SECTION 4.55(2) APPLICATION

**88 CHRISTIE STREET,
ST. LEONARDS**

This Section 4.55(2) modification application has been prepared by Urbis Pty Ltd on behalf of Christie Street Development Pty Ltd (**JQZ**) (**the Applicant**) to amend Development Application DA 6/2018 for the construction of a mixed-use development at 71-79 Lithgow Street, 82-90 Christie Street, and 546-564 Pacific Highway St Leonards.

Figure 2 – Location of new public lift on Ground Level

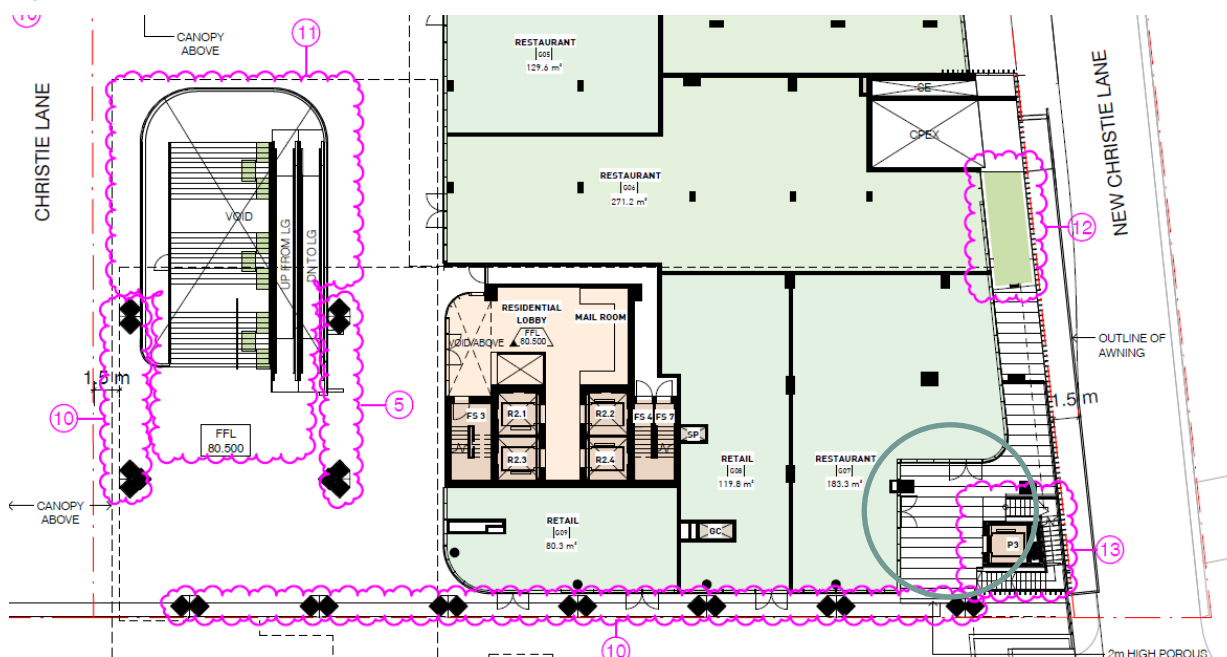
To allow for improved accessibility from New Christie Lane, this modification seeks to relocate the public lifts and stairs to the south west corner of T1, illustrated in **Figure 2**. The proposed public lifts are to be relocated in a highly visible and convenient location. The lift will provide access between Lower Ground, Ground and Level 01.

Figure 3 – Proposed amendments to the site plan

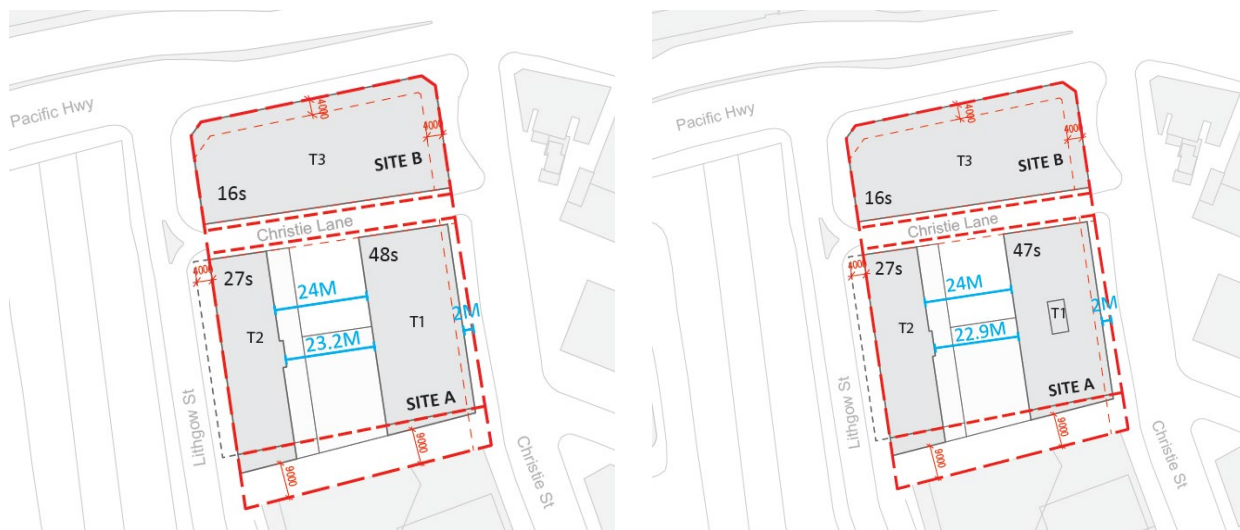
The following changes to the overall built form are proposed to allow for adjustments which have been realised during design development and to ensure consistency with the proposed amendments outlined in this modification.

Figure 4 – Reduced northern setback of T2

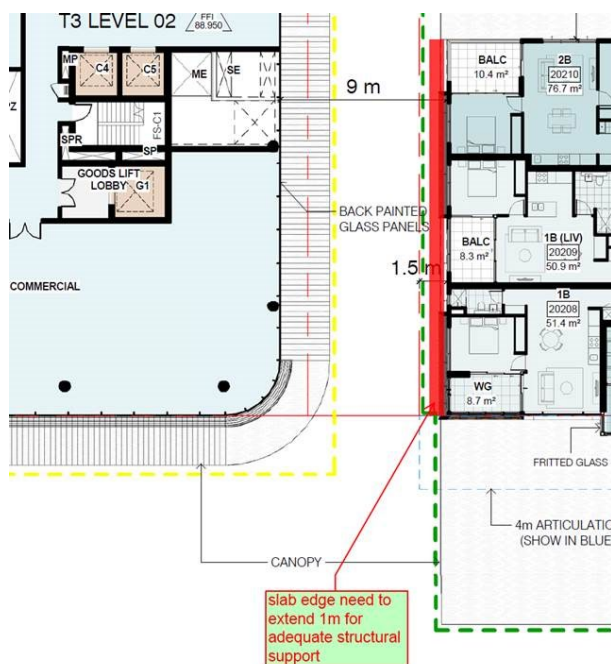
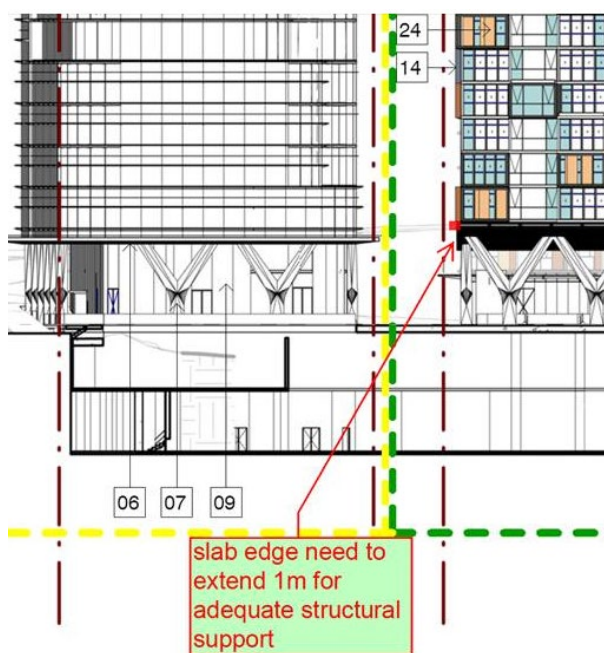
An additional approximate 300mm projection to T2 is also necessary to provide adequate structure support and allow for an enlarged service platform. This projection will reduce the current building separation between T2 and T3. The T2 core amendments respond to both technical and hygiene considerations, which require the louvred platform to be extended 300mm further to the east to accommodate the AC units as well as the kitchen exhaust from retail below.

Changes to the northern façade of T2 are proposed to allow adequate structural support. The proposed changes result in a reduction of the setback above the podium. As illustrated in **Figure 4**, the protrusion is unlikely to be visible to pedestrians due to the existing awning. As the protrusion is only located on Level 02 and not higher it will not contribute significantly to the overall bulk and scale of the building.

Figure 6 – View Lines for St Leonards

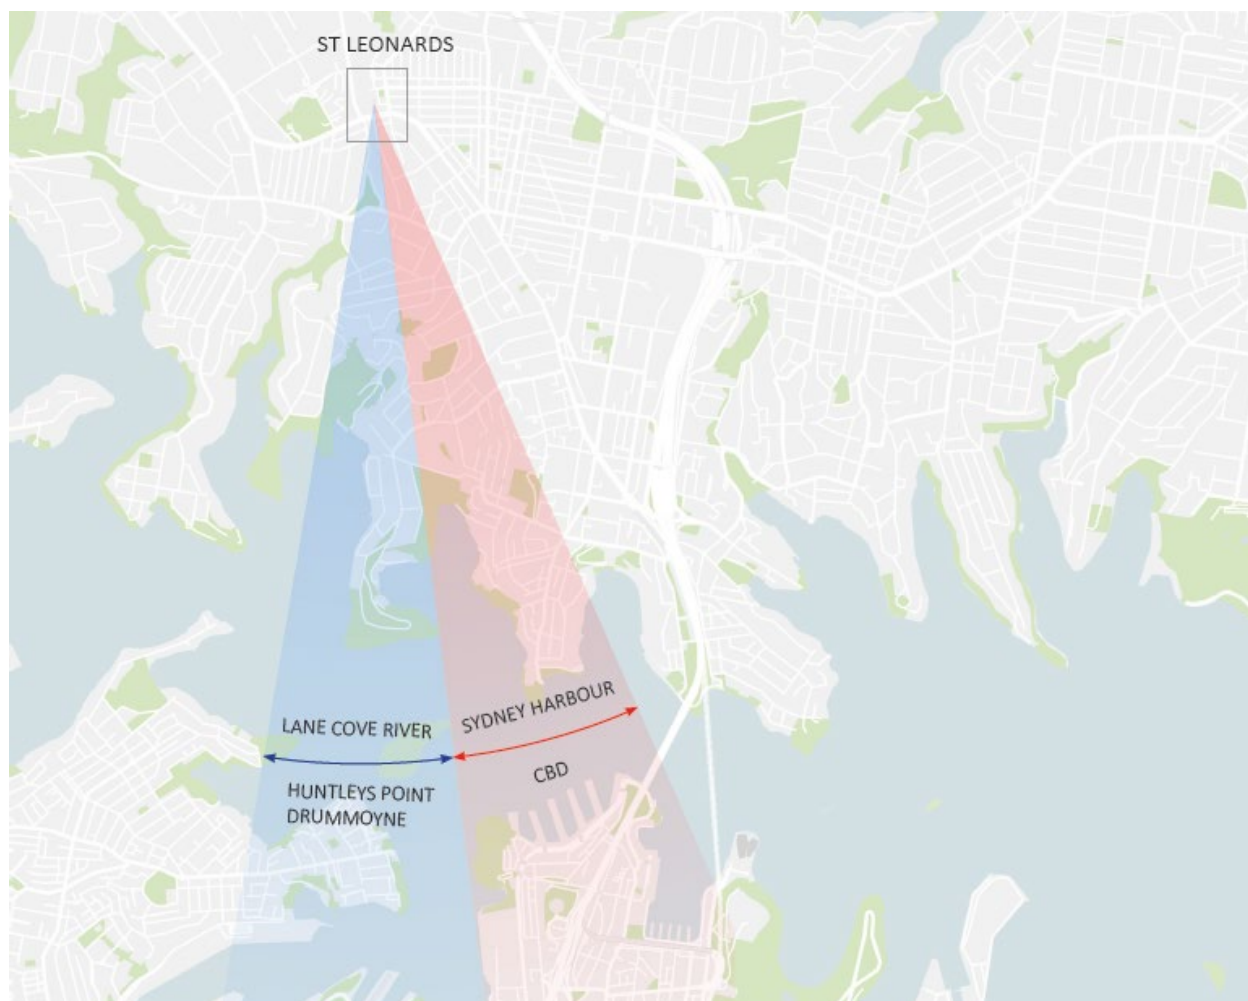
As illustrated in **Figure 6**, Forum East has views to the west of Lane Cove River and Sydney Harbour to the south. The approved development already interrupts views to Sydney Harbour including the Opera House and Harbour Bridge. Views to the south are now impeded and are viewed between the approved T1 and T2 towers.

Figure 7 – View Analysis

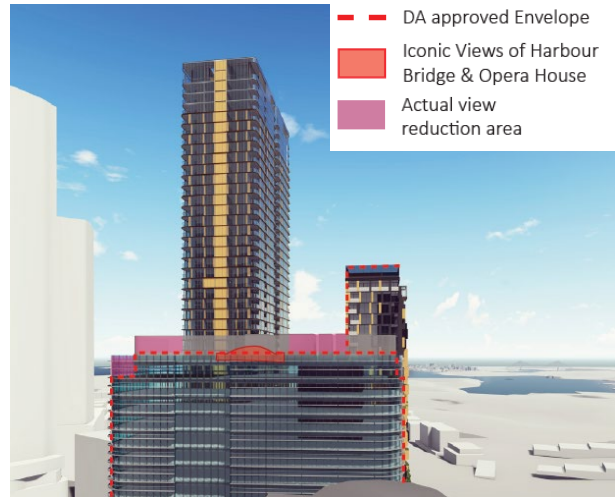
The findings recognise that the proposed modifications do result in minor additional view impact which are limited to four levels of the Forum East. View impacts are still improved under the proposed change compared to the view impacts that would result from the construction of an 18-storey building previously approved at 88 Christie Street to the rear.
